Sent: Tuesday, 20 September 2016 10:58 AM
To: Fiona Gibson
Cc: Myfanwy McNally
Subject: SSD 6387 MOD 4 – 1 Burroway Road – Wentworth Point - Council Submission

**SSD 6387 MOD 4 – 1 Burroway Road – Wentworth Point
Section 96(1A) amendment to approved mixed use development
City of Parramatta Submission**

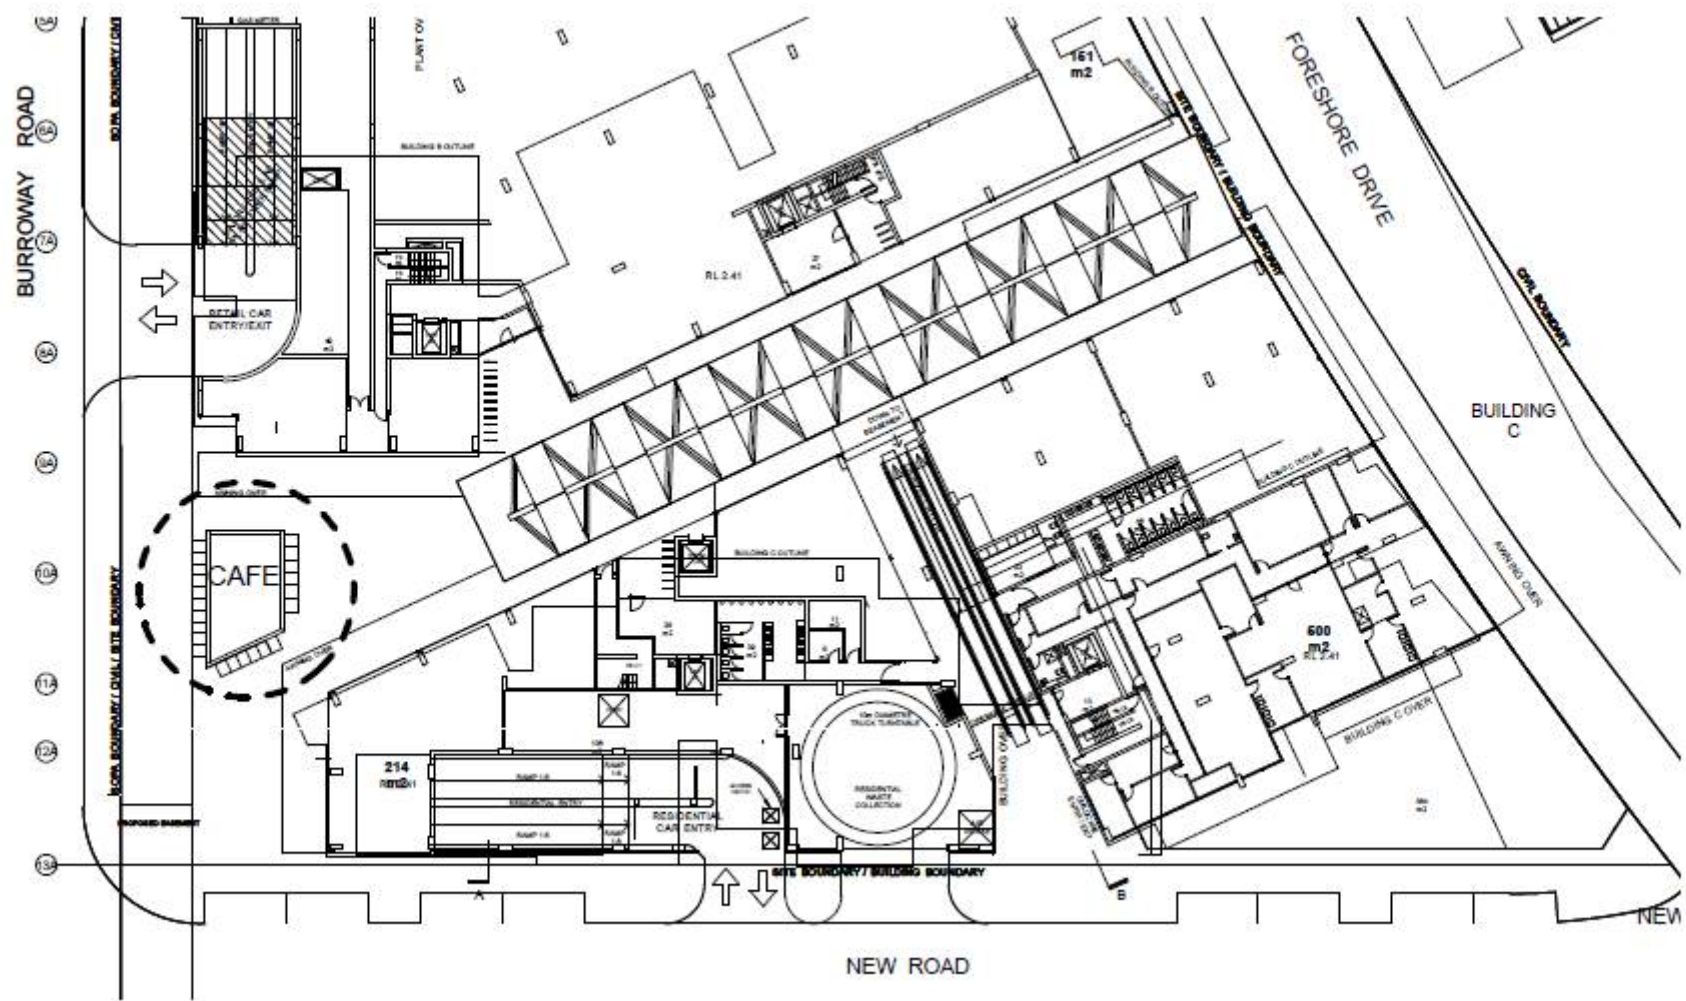
No significant concerns are raised, however it is noted that details of the location of supporting structures have not been provided. In this regard, sufficient pedestrian movement should be maintained throughout the plaza area and appropriate access for people with disabilities will need to be achieved.

Significant concern is raised with the proposed location of this café. It is a single high structure standing at 3.8m high. It is located at the southern end of the plaza and impedes the visual connection from Burroway Road through the plaza towards the water and the ferry terminal. It also utilises an area which is the gateway to the plaza and impacts upon pedestrian usage (including impeding pedestrian flow). The pedestrian entry to the ferry terminal needs to be clearly defined within the streetscape. It is considered that whilst a café may be an appropriate use within the development site, it should be contained within the ground floor retail component of the development, and not encroach on pedestrian areas. With respect to the above, it is considered that the proposed location of the café does not provide for an appropriate urban design outcome for the public domain.

It is noted that within the Secretary's Environmental Assessment Report for the original application that the SOP Master Plan 2030 applied to the site. It appears that the proposed modification (for the café component) would not comply with the setback and through site link requirements of this master plan. The assessment report also acknowledges the *"proposed pedestrian through-site link ... provides direct and obvious access to the adjacent ferry and bus interchange in accordance with SOP Masterplan"* which appears to justify the non-compliance with setbacks in the original approval. It is therefore considered that the integrity of the Burroway Road setback and provision of the through site link would be further compromised and contrary to the assessment of the original approval. In this regard, it is considered that the location of the café would not allow for the direct and obvious access to the ferry and bus interchange.
